RICHMOND COMMUNITY SCHOOL
Richmond High School: Mechanical Modernization Project
LWC Commission No. 20104.02

ADDENDUM #03
October 3, 2021

Comm. No.	Date
	20104.02	08.27.2021
	Drawn	Drawing No.
Checked	NGM	E203
	JAE

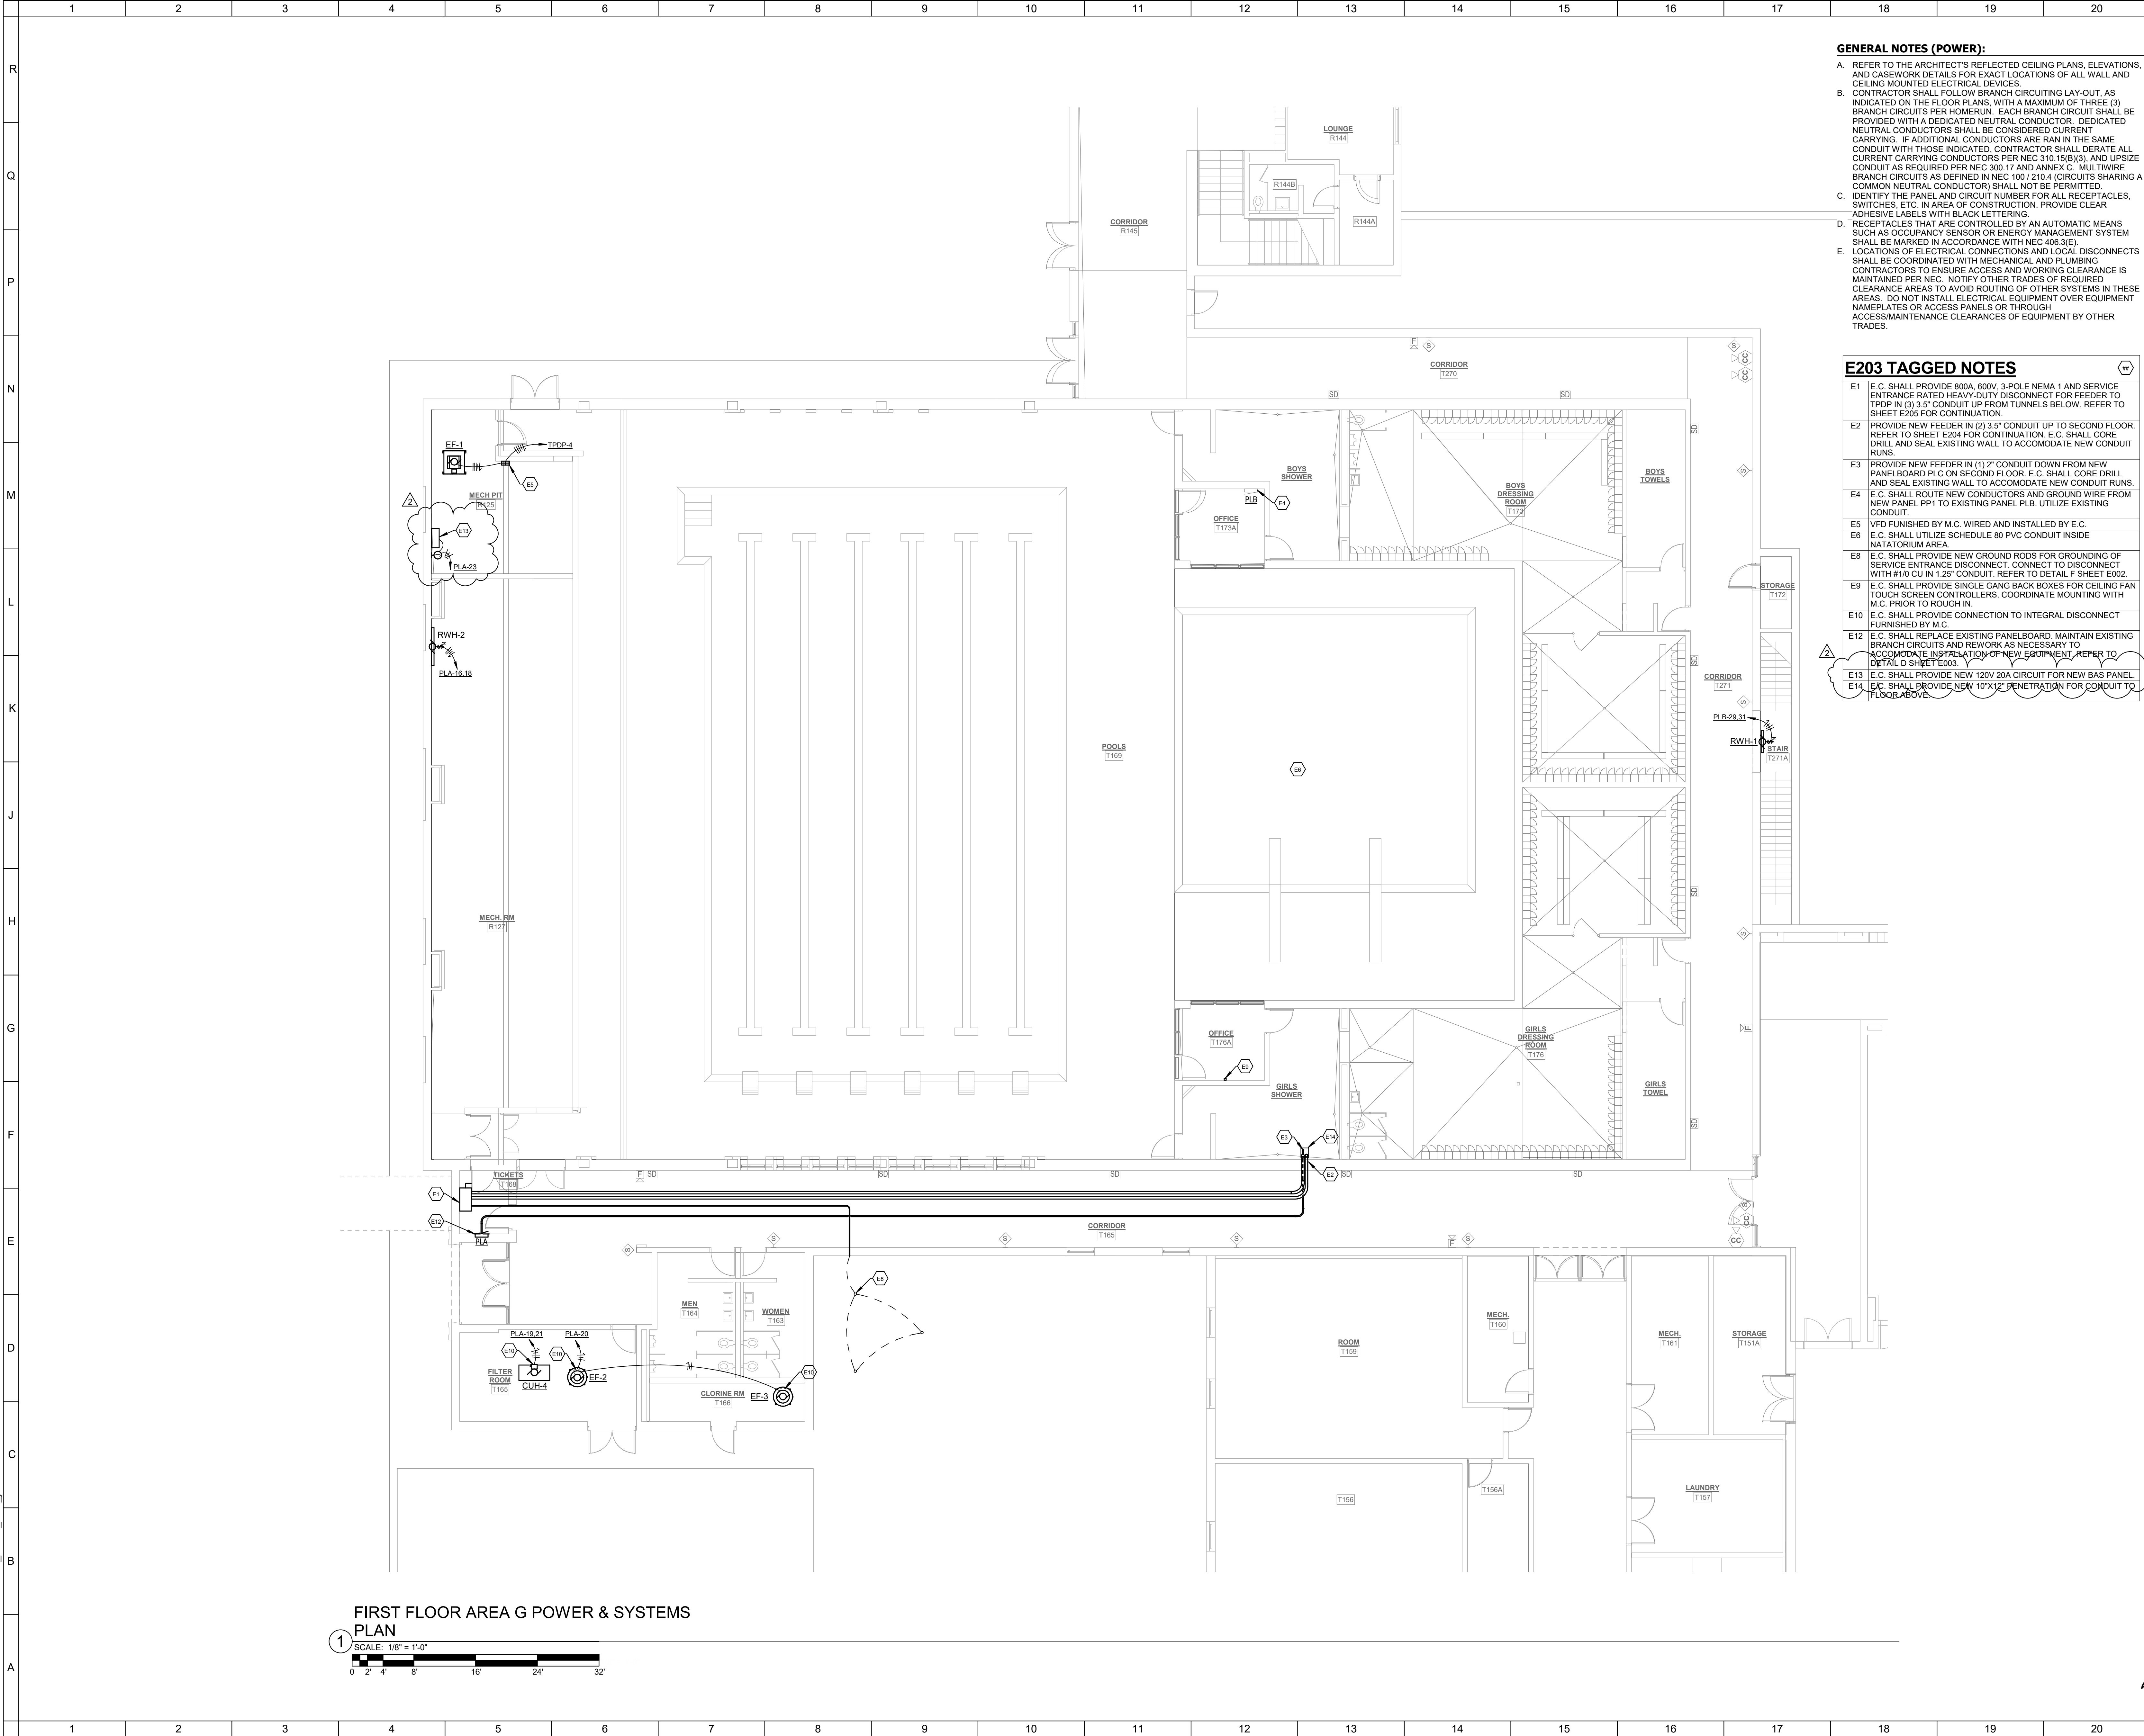
ITEM NO.10 Drawing E203

- A. Added power for new BAS panel in mechanical room.

Comm. No.	Date
20104.02	08.27.2021
Drawn	Drawing No.
NGM	E204
Checked	JAE

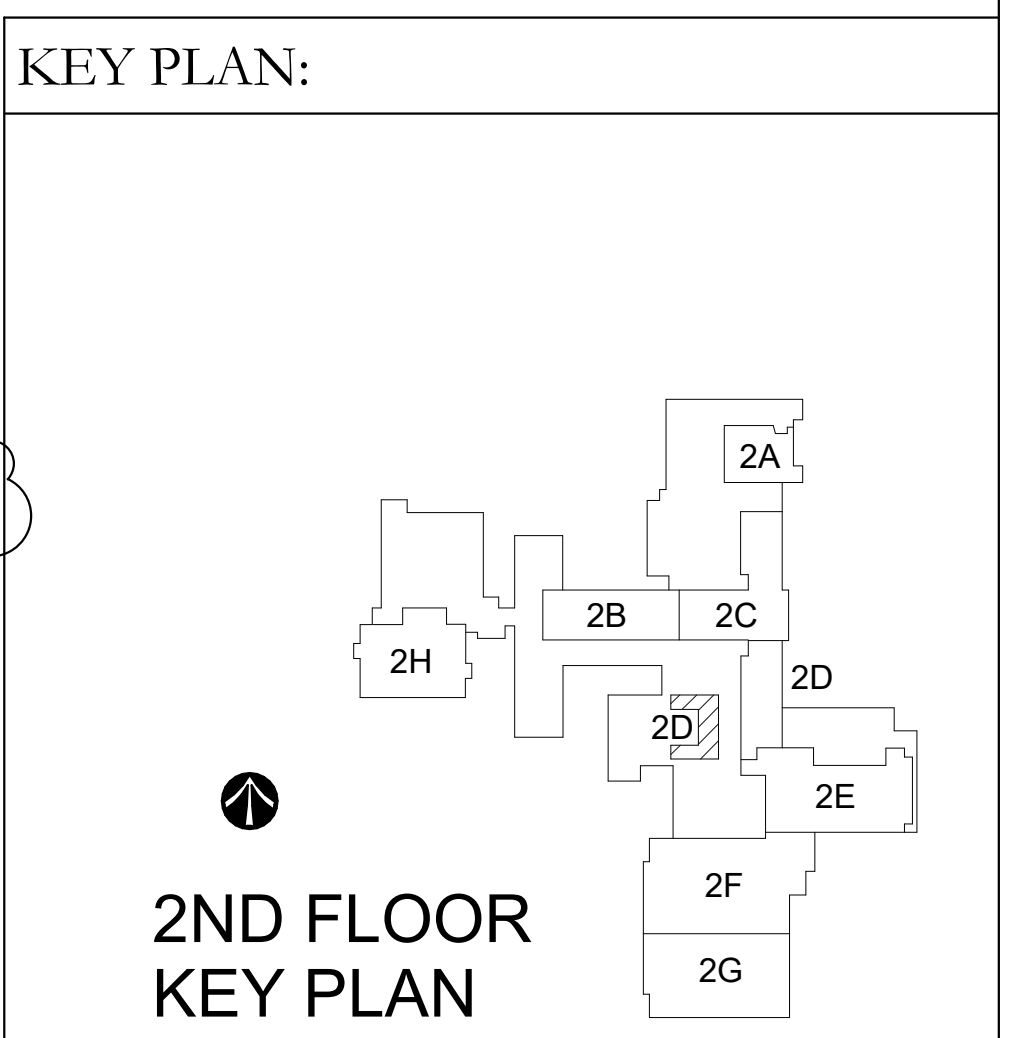
ITEM NO.11 Drawing E204

- A. HVLS fan VFD to be mounted near ceiling.
- B. Added power for new BAS panel in each mechanical room.
